**CLIFTON PARK WATER AUTHORITY
BOARD MEETING**

Re: Clifton Park Water Authority – Tank Inspection Report Summary and Recommendations

Subject: Knoll Top Tank Sprint Removal Inspection Report

3. Grounding wire just cut and left

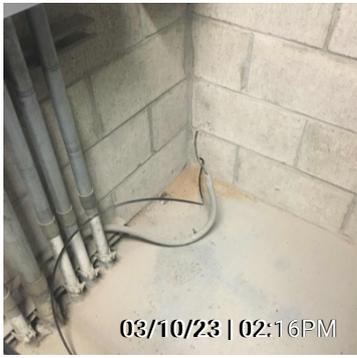
1. Blanket materials were left behind. See Note 2 of the attached report.
2. The grounding wire that served the Sprint equipment was left in place. See Note 3 of the attached report.
3. Miscellaneous support brackets that supported Sprint equipment were left in place. See Note 4 of the attached report.
4. Conduit penetration and junction box covers which served Sprint equipment were not sealed. See Note 5 of the attached report.
5. Holes in the tank exterior cladding were not sealed. See Note 6 of the attached report.
6. The antenna mounts on the tank were left in place. See Note 8 of the attached report.
7. The paint utilized to for the areas impacted by the equipment removal does not match the color of the existing tank. The existing tank paint is Tnemec Fascinate 02GN. See Note 9 of the attached report.
